HARRISVILLE CITY

Harrisville City Planning Commission Harrisville City Offices Wednesday, May 10, 2023

AGENDA

RE: **HARRISVILLE CITY PUBLIC WORKS BUILDING**
Final Site Plan Review

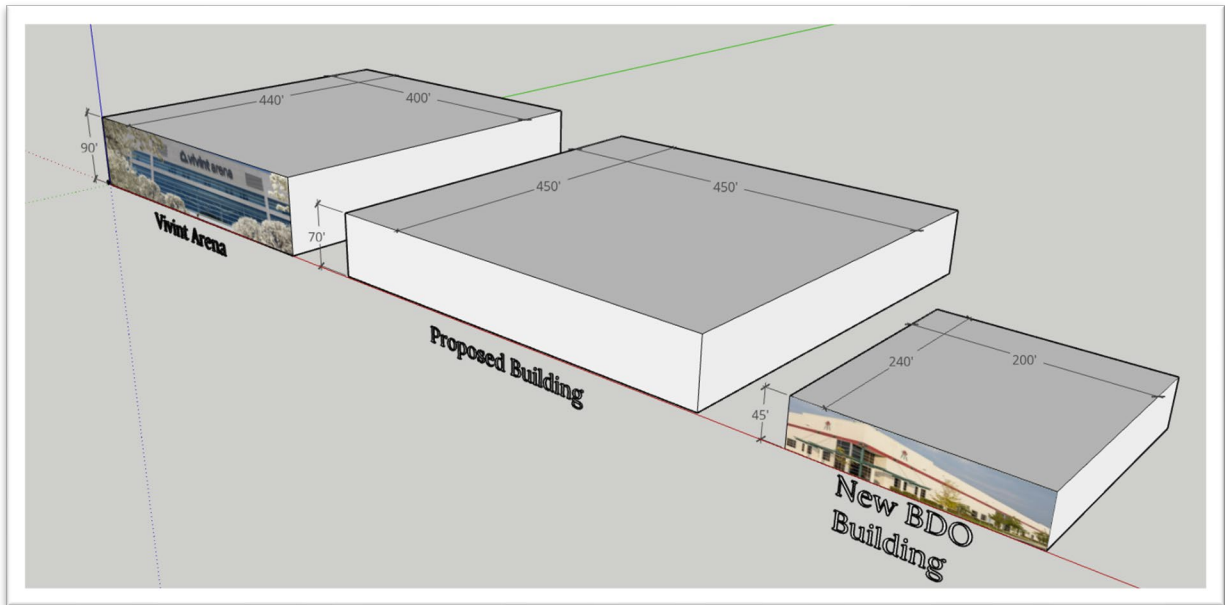
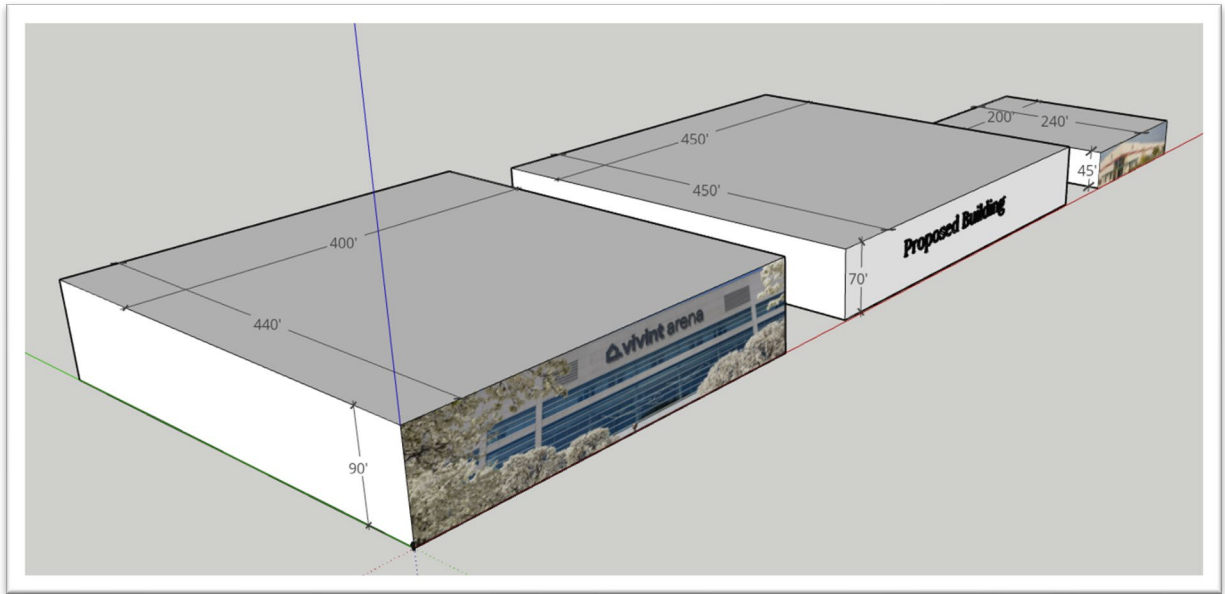
Staff has prepared a review of the proposed height of 70 feet compared to the current code of 45 feet.

The Vivint Arena in downtown Salt Lake City has an approximate height of 90 feet. The prefabricated concrete building in the Ogden Business Depot has an approximate height of 45 feet. The picture above shows a comparison of the proposed athletic facility to existing buildings as a visual reference.

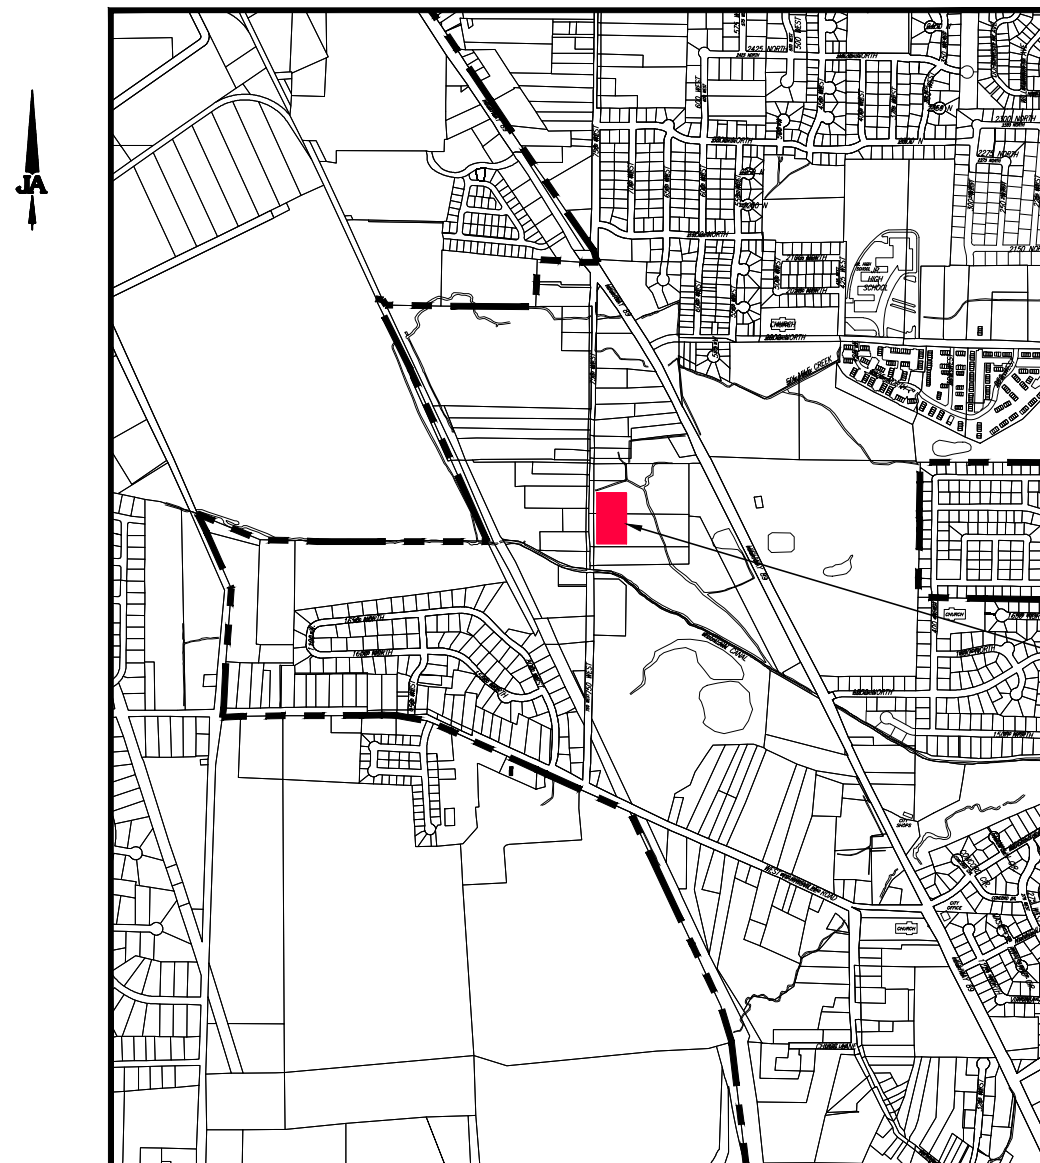
Our office has been working with City Staff, the project Architect, and the Contractor on the design of the new Harrisville City Public Works Building and associated improvements located at approximately 1750 North 750 West. We have worked through review comments with the project design team and utility providers and completed the final site plan and improvement drawings. We recommend final approval of the site plan subject to the following comments:

1. Obtain a Will Serve letter from Bona Vista for the culinary water improvements. Bona Vista has reviewed the plans and we have revised the plans per their recommendations. They are checking their water model with the overall city campus, future manufacturing, and future commercial development in the area in mind and will provide us with the recommended water main size in 1750 North.
2. We are working with Rocky Mountain Power and Dominion Energy on how to run services to the new building. Obtain final approval from these utility providers for the new services.

We will continue to work with these utility providers for these new services and this will be completed prior to construction. Please let me know if you have any questions.

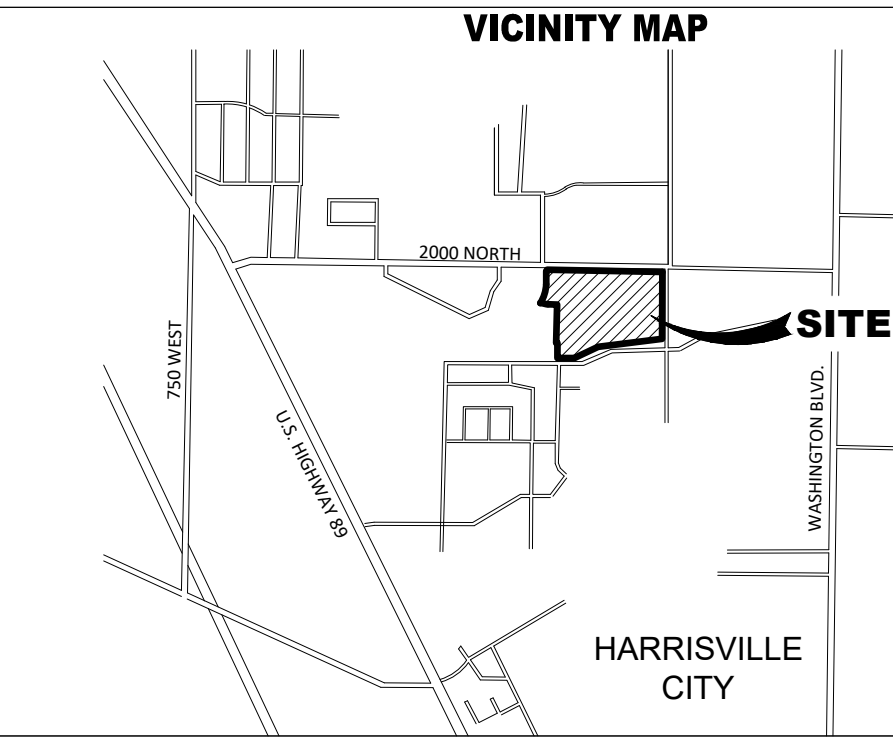
Our office has completed a review of the final plat and improvement plans for the Ben Lomond Phase 2-D Subdivision located in the golf course mixed use zone. This phase includes the construction of the northeast section of the overall development and has 122 residential units including single family and multi-family units. Phase 2-A of the overall site will need to be constructed prior to construction of this phase as several of the street accesses and the utility connections will be built in Phase 2-A. There are still several outstanding items that need to be addressed for Phase 2-D:

1. The asphalt tie-in and new curb and gutter elevations on 2000 North need to be portrayed in more detail on the plans. Additional asphalt and grading work may be required on the existing 2000 North roadway to ensure that it drains properly and matches the proposed curb and gutter.
2. The pavement section for the new roadways should match the City Standard (which is also what was approved in Phase 2-A).
3. Provide a "Will Serve" letter from Bona Vista Water for the culinary water improvements.
4. Provide a final approval letter from North View Fire District.
5. Provide improvement plans for the parks and open space included in this phase. Also, provide details or a plan for the required landscaping for this phase including street trees.

1. Complete a Storm Water Pollution Prevention Plan (SWPPP), file a Notice of Intent (NOI) with the State, and obtain a Stormwater Activity Permit from the City before any construction begins.
2. An engineer's estimate for the cost of the public improvements needs to be submitted and approved by our office before the pre-construction meeting and will be the basis for the developer's agreement and the associated construction guarantee.
3. The final set of plans will have a "City Engineer Acceptance" stamp and will be the only set of plans to be used during construction.
4. Prior to construction, the Developer and the Contractor must hold a pre-construction meeting with City staff to review construction requirements.
